**CHESTER BOROUGH LAND USE BOARD  
AGENDA  
DECEMBER 10, 2020  
7:00 PM**

Re: Amended Preliminary & Final Site Plan and Variance Application  
128 Main Street  
Block 123, Lots 1 & 2  
Our Project No. 20CB205

Subject: Preliminary and Final Major Site Plans- Landscape Review

FIGURE 500-08		
MORRIS COUNTY TYPICAL DETAIL GRANITE BLOCK CURB		
NOT TO SCALE	12/2019	WMW

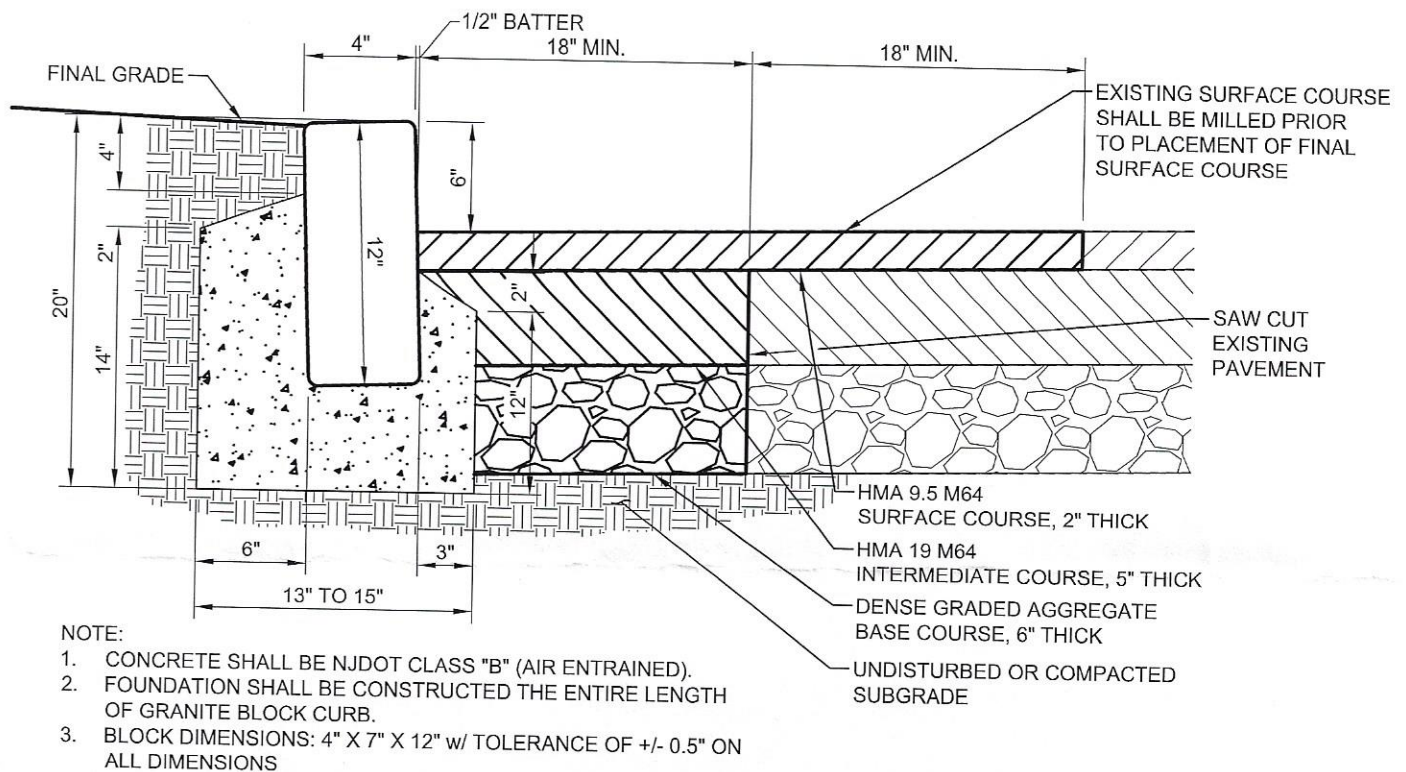
38. Water tight joints should be specified for the proposed storm sewer system.
  39. Correct the batter note (1'-6") on the granite block curb detail (1" batter).
